CCB 7323
Pre and Post Change Summary
PCN #: CENO-13VISL488

Pre and Post Change Summary – UV Dicing Tape

D-176: Clear UV Tape

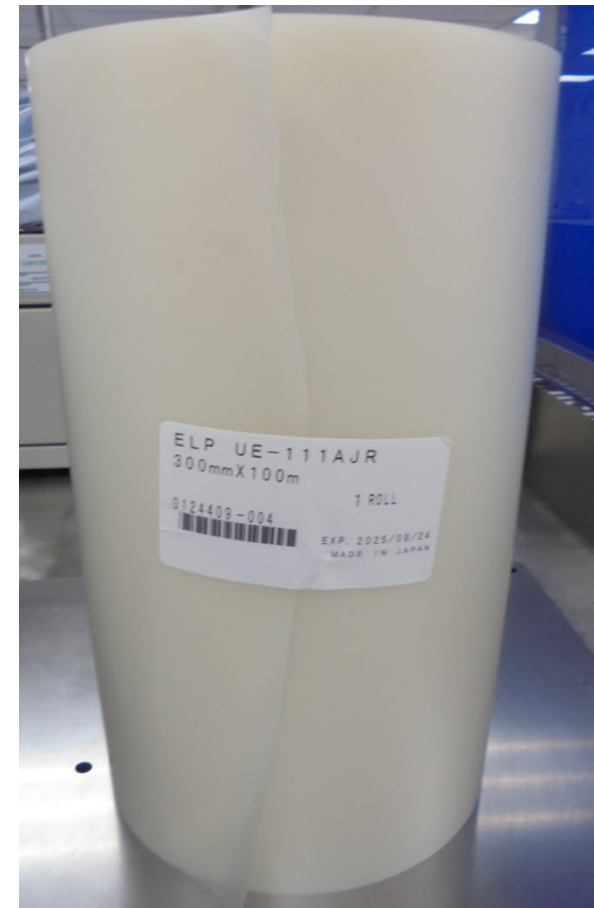
Pre change

Post Change

D-176D: Blue UV Tape

UE-111AJR: Clear UV Tape
